Nuclear Reactor Laboratory

SUBJECT: Resubmittal of package dated September 8, 2004: *Eliminate Reactor Health Physicist Position and one hour on-call requirement from Technical Specifications.*

SUBJECT: Eliminate Reactor Health Physicist Position and one hour on-call requirement from Technical Specifications.

Justification for September 2004 Changes to UIUC Nuclear Reactor Laboratory Technical Specifications, Docket 50-151

CHART I

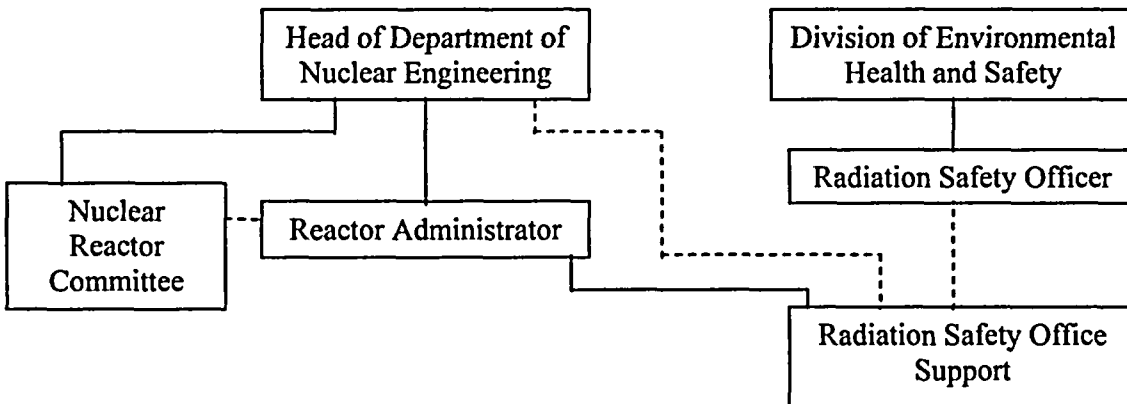
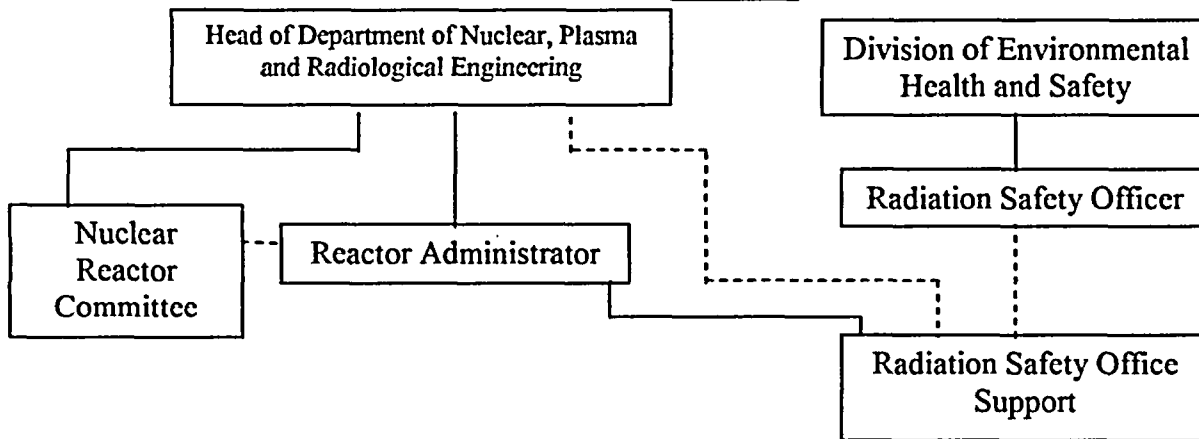
2. *The Reactor Health Physicist is replaced by "Radiation Safety Office Support".*
Deleted: Reactor Health Physicist
3. *The position of Reactor Health Physicist at the reactor has been eliminated.*
Deleted: 2 Reactor Health Physicist. This individual shall meet the requirements of ANSI/ANS-15.4-1988 "American National Standard for the Selection and Training of Personnel for Research Reactors" for a Level Three individual in addition to training in health physics.
